Product Discontinuation Notice

No.ICDRY-080040

Solid State Relays (Single-phase) G3PB series

Solid State Contactors (Three-phase) G3PB-2(N)/-3(N) series

(Relevant model : G3PB-215B/225B/515B/-VD)

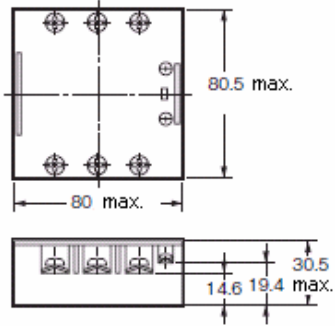
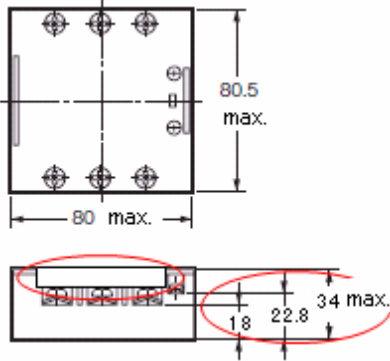
Product discontinuation	Recommended replacement
	Note : The change of terminal cover to improve finger protection.
